D407-667-105TRN
Job Sheet 173569

Part Name: Crosstube Turning Detail

DRAWING NO. D407-667-145	TITLE CROSSTUBE ASS'Y (407 HIGH FWD)	REV. C	DART AEROSPACE LTD ENGINEERING ORDER		D.E.O. NO. D407-667-145-C-1	SHEET NO. SHEET 1 OF 1	SCALE NTS
DRAWN QP	CHECKED ASS	MFG. APPR. IB	APPROVED WD		DE APPR. H		
DATE 11.07.15	DATE 11.07.22	DATE 11.07.22	DATE 11/07/22		DATE 11.07.21

DRAWING NO. D407-667-145	TITLE CROSSTUBE ASS'Y (407 HIGH FWD)	REV. C	DART AEROSPACE LTD ENGINEERING ORDER	D.E.O. NO. D407-667-145-C-2	SHEET NO. SHEET 1 OF 1	SCALE NTS
DRAWN AJS	CHECKED	MFG. APPR.	APPROVED	DE APPR.		
DATE 12.08.02	DATE 12.08.02	DATE 12.08.02	DATE 12.08.02	DATE 12.08.02	DATE 12.08.02

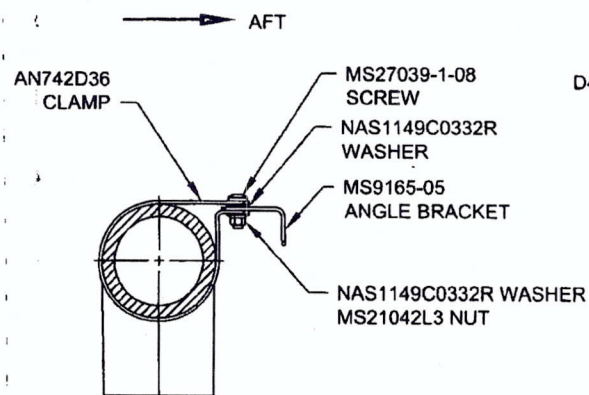
ADD ELECTRICAL GROUNDING STRAP

- 16) MASK AREA UNDER CLAMP PRIOR TO PAINTING
- 17) SEAL EDGES WHERE AN742D36 CLAMP MEETS WITH THE CROSSTUBE USING SIKAFLEX-241/-291 OR MIL-S-8802 CLASS B2 OR PROSEAL 890 SEALANT
- 18) PERFORM RESISTANCE CHECK TO ENSURE MAX RESISTANCE IS 10 MILLIOHMS
